PRODUCT ADVISORY NOTICE

Subject: 62D Die Cast Bushing Retooling

Equipment Under Test:
621413 Bushing (62D Encoder)

Test Report Number:	SP02-2635
Test Start Date:	07/10/2019
Test Completion Date:	07/22/2019
Test Facility:	Grayhill Rotational Life Cycle Lab.
Test Requested By:	Jason Kifer Engineer
Test Performed By:	Neringa Noreika Quality Technician
Report Written By:	Neringa Noreika Quality Technician
Report Approved By:	Rupinder Bains Quality Lab Manager

Figure 2- Average CW & CCW Rotational Torque

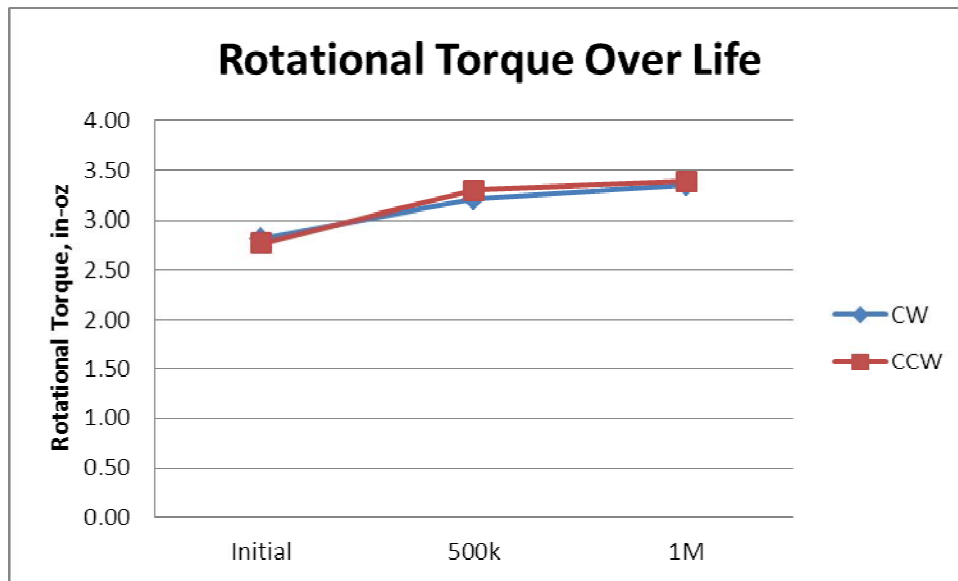
Rotational Life testing of 62D encoders built with 621413 bushings from new alternate supplier.

All DUT are subject to the same pass/fail criteria. A test unit is deemed to have failed if the encoder has a bind of the switch shaft or if the spring has failed (no detent). Although torque readings are taken, the failure criteria is easily identified as increased torque, drag or binding of the shaft/bushing interface.

DUT	Test	Specification	Pass	Test Location	Test Date
1 - 30	Rotational Life	MIL-STD-202G, Method 206	Pass	Grayhill Rotational Life Cycle Lab	07/10/2019 07/22/2019
